THM 4L60-E

CHANGE:

Beginning at the start of production for all 1996 models, the THM 4L60-E transmissions were built with a new design "On-Off" 3-2 downshift solenoid, and a new design 3-2 downshift valve line-up in the valve body.

Figure 1

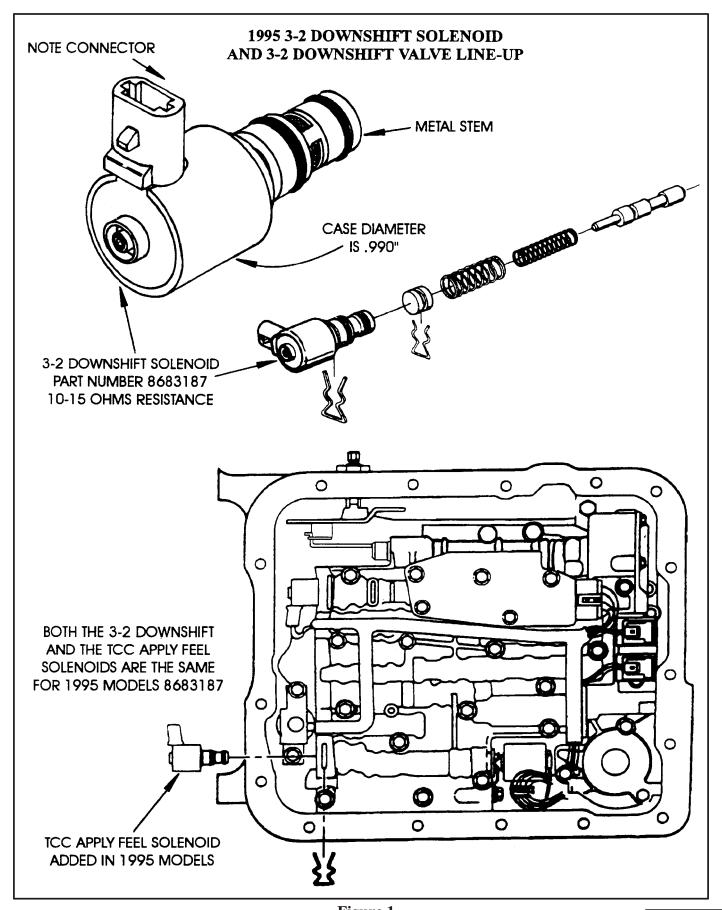
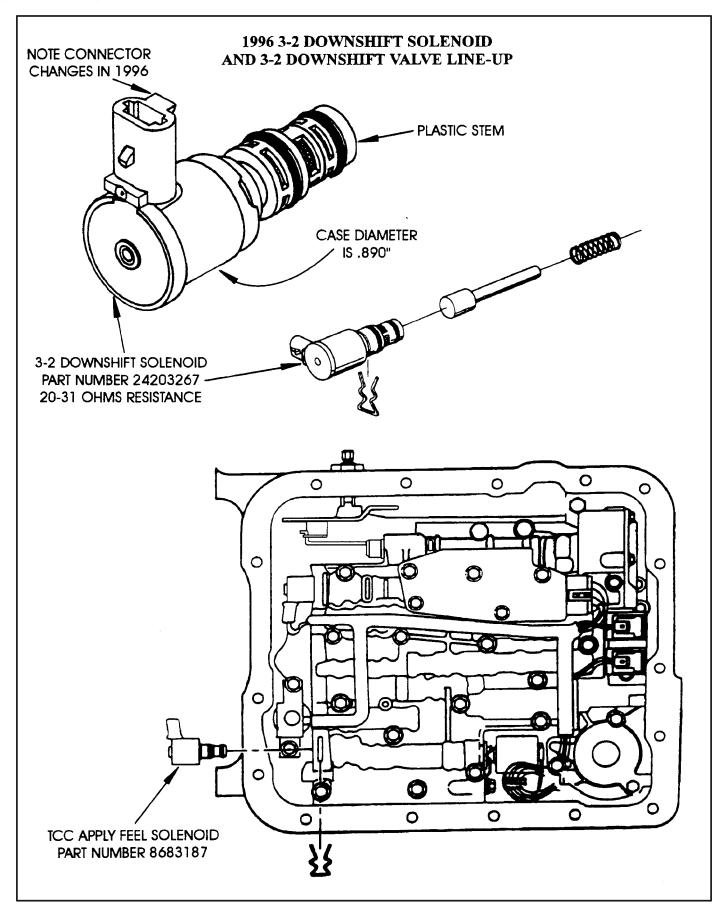
- (1) 3-2 DOWNSHIFT SOLENOID Changes from a Pulse Width Modulated (PWM) solenoid to a regular "On-Off" (Normally Open) solenoid, which also requires a different Power-train Control Module (PCM). The new design "On-Off" 3-2 downshift solenoid can be identified by the case diameter, which is smaller than the previous design, and the new design solenoid also has plastic stem that fits into the valve body bore, where the previous design was metal. The solenoid connector was also changed to prevent the solenoids from being accidentally installed in the wrong models. Refer to Figure 1 for 1995 models, and Figure 2 for 1996 models.

- (2) 3-2 DOWNSHIFT VALVE The entire 3-2 downshift valve line-up changes to accommodate the new design "On-Off" 3-2 downshift solenoid. Refer to Figure 1 for 1995 models, and Figure 2 for 1996 models.

Figure 3
AUTOMATIC TRANSMISSION SERVICE GROUP

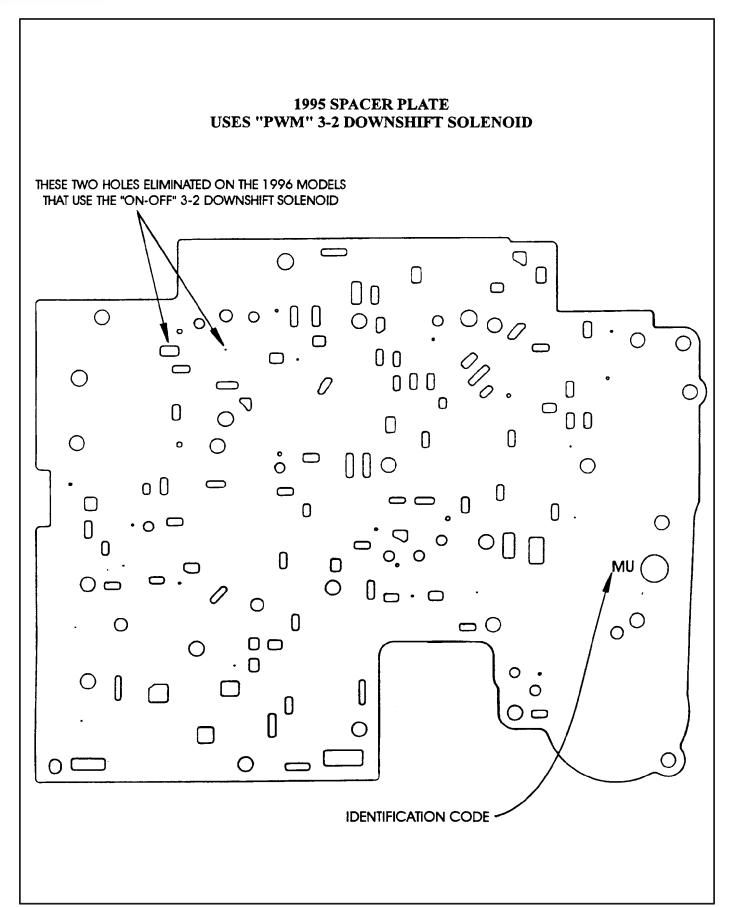
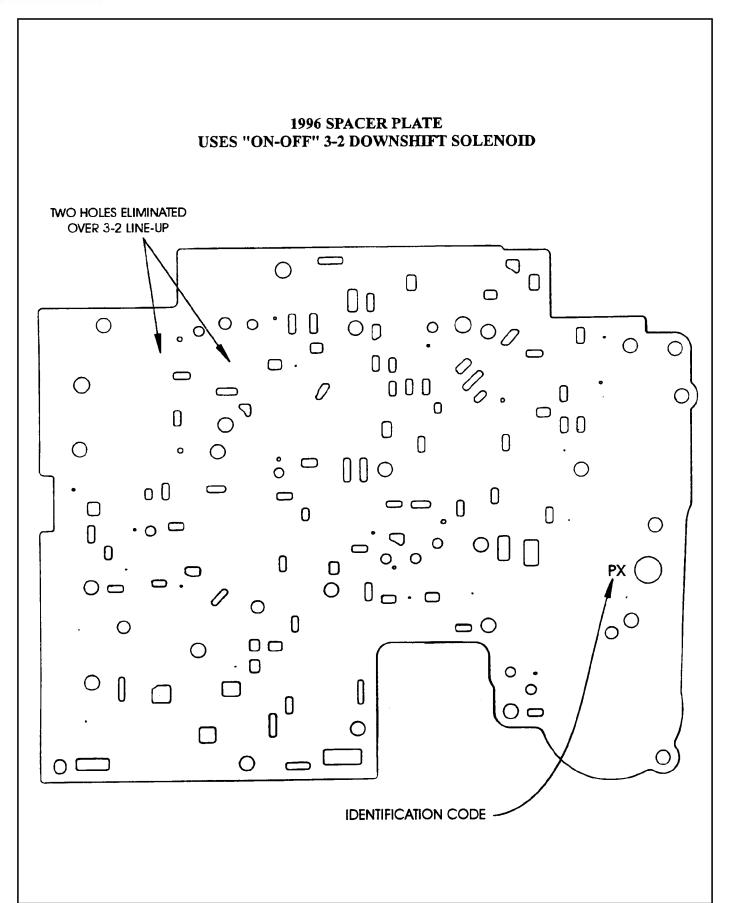
- (3) VALVE BODY SPACER PLATE There were two holes eliminated in the 1996 spacer plate, over the 3-2 downshift valve line-up, to accommodate the new design 3-2 downshift valve. The 1995 spacer plate can be identified with the first letter of the two digit code being either an "M" or "N", as shown in Figure 3. The 1996 spacer plate can be identified with the frost letter of the two digit code being a "P", as shown in Figure 4.
